# CONTINUING ELIGIBILITY INSPECTION (CEI) REPORT

1. Project Name: Keōpū Stream Flood Control Project

2. Date of Inspection: December 16, 2004

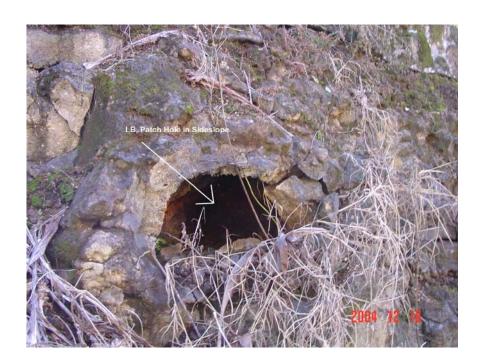
b. Top of Project, Upstream of Māmalahoa Highway Bridge, RB remove vegetation and debris from top of channel.

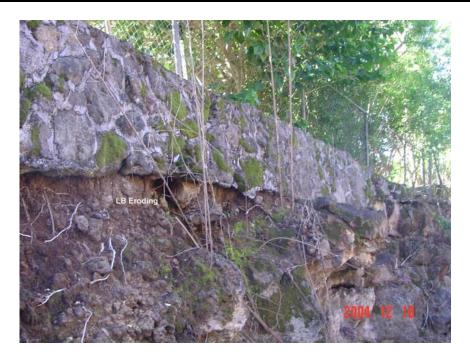
f. LB, fill hole in sideslope.
